## PLANNING COMMISSION MEETING STAFF REPORT

**NAME OF PROJECT:** Lucerne Estates

**AGENDA ITEM:** Preliminary Approval

**Subject: Lucerne Estates Subdivision, – Preliminary Approval**

RD DEVELOPMENT GROUP LLC  
 LUCERNE ESTATES  
 SITE PLAN

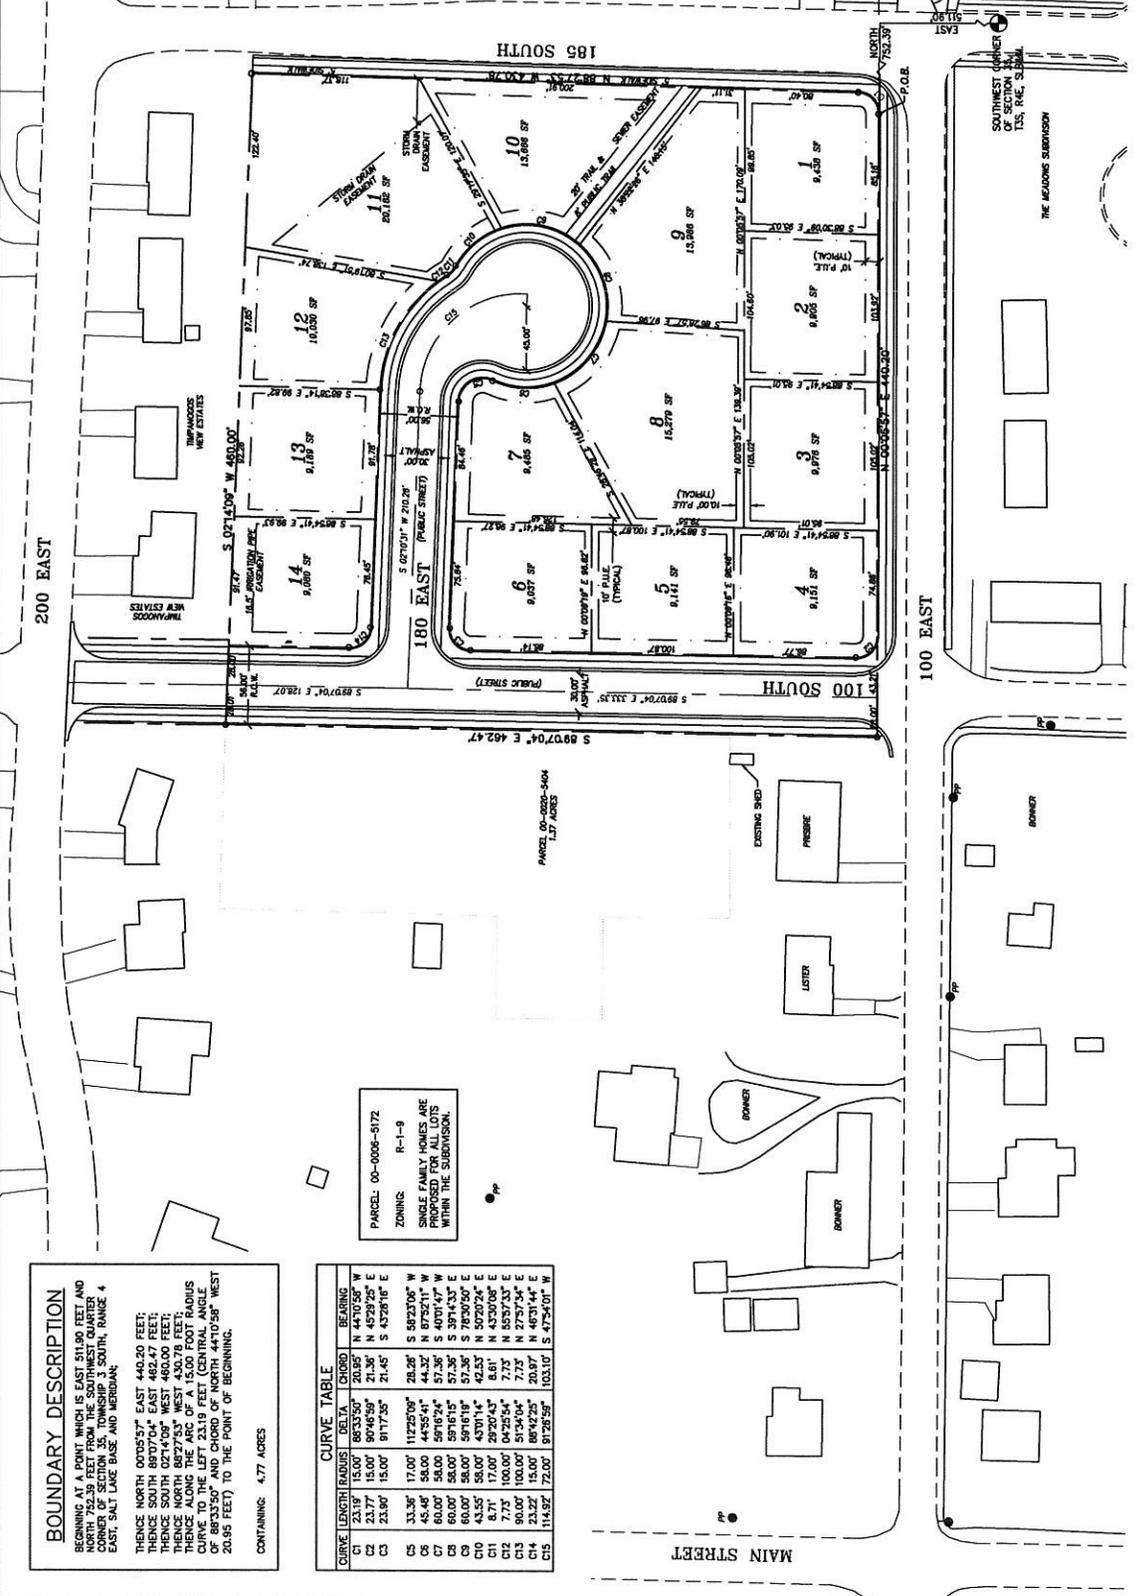
- The proposed development will be served from the Gerber Mahogany pressure zone.
- The proposed development will connect to the existing 12" culinary water line in 100 East and the existing 6" culinary water line in 200 East.
- 8" water lines will be installed within the development. The proposed culinary water system will provide adequate fire flows.

- A new road is proposed to be installed on 100 South from 100 East to 200 East. All new roads will have a cross section of 30' of asphalt, modified curb & gutter, a 5' park-strips and 5' sidewalks.
- Due to the roadway dedication on Michie Lane, Midway City will be dedicating 185 South, the roadway directly in front of the Midway Elementary to the Wasatch School District.

- The storm water within the proposed development will be collected and dispersed through the use of catch basins, sumps, and retention basins.
- For maintenance a utility easement within 185 South needs to be provided to maintain access to the storm drain pond and sumps.
